Enfield Street Corridor June 29, 2016

OFFICE OF INTERMODAL PLANNING BUREAU OF POLICY AND PLANNING CONNECTICUT DEPARTMENT OF TRANSPORTATION

#### 1 Introduction to the Enfield RSA

Figure 22. Short Term Recommendations

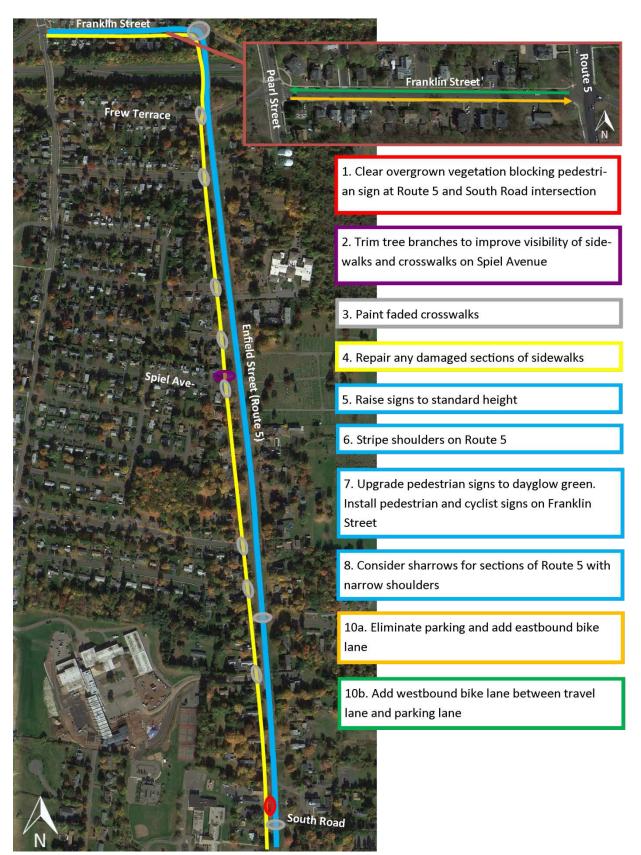
- 1) Clear overgrown vegetation blocking signs, such as the pedestrian sign on the southbound side of Route 5 at the South Road intersection (Figure 15).
- 2) Along the sidewalks, trim tree branches near the crosswalks to improve visibility of pedestrians.
- 3) Paint faded crosswalks (Figure 16).
- 4) Repair any damaged sections of sidewalks (Figure 17).
- 5) Raise signs to standard height to improve visibility (Figure 18).
- 6) Stripe shoulders on Route 5 (Figure 19).

- 7) Upgrade all pedestrian and advanced warning signage to dayglow green (Figure 20). Install pedestrian and cyclist signs on Franklin Street.
- 8) In areas of Route 5 where the shoulder area is narrow, considering adding sharrows to the travel lanes.
- 9) Install "No Parking" signs near the crosswalks on the side streets of Route 5 to prevent vehicles from blocking the crosswalk or obstructing visibility of pedestrians using the sidewalk and crosswalk.
- 10) Designate bike route on Franklin Street:
  - a) Eliminate parking on the southern side of Franklin Street and paint a contraflow bike lane for cyclists travelling eastbound towards Route 5.
  - b) Paint westbound bike lane between travel lane and parking area.

Figure 30. Long Term Recommendations

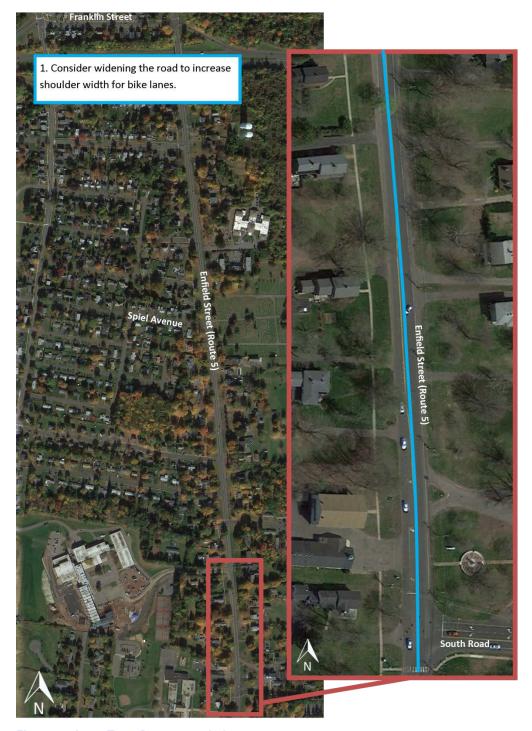
1) In areas of Route 5 where the shoulder area is narrow, consider widening the road to increase shoulder width for use a bike lane.
